BECHTEL
 PEACH BOTTOM ATOMIC POWER STATION UNITS No. 2 & 3
 PHILADELPHIA ELECTRIC COMPANY
ELECTRICAL INDEX E-2008
RACEWAY & GROUNDING LAYOUT
PUMP STRUCTURE UNIT 3

NO.	REVISED BY	DATE
6280	E-1008	23

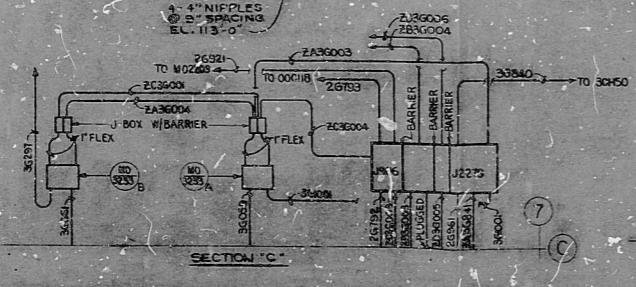
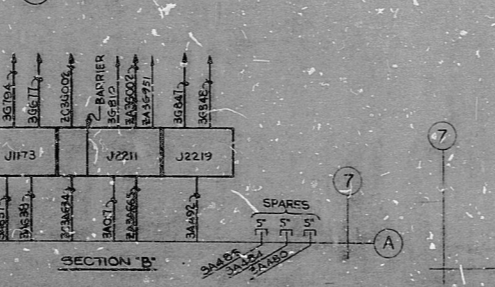
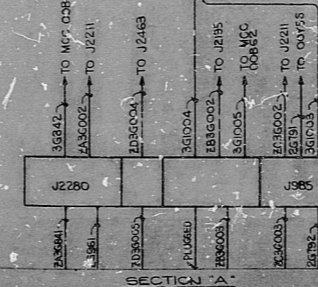
CA 2071-815 MOD 573
 1. REMOVED JOINT FROM 30606 TO 30607
 2. REMOVED JOINT FROM 30606 TO 30607
 3. REMOVED JOINT FROM 30606 TO 30607
 4. REMOVED JOINT FROM 30606 TO 30607
 5. REMOVED JOINT FROM 30606 TO 30607
 6. REMOVED JOINT FROM 30606 TO 30607
 7. REMOVED JOINT FROM 30606 TO 30607
 8. REMOVED JOINT FROM 30606 TO 30607
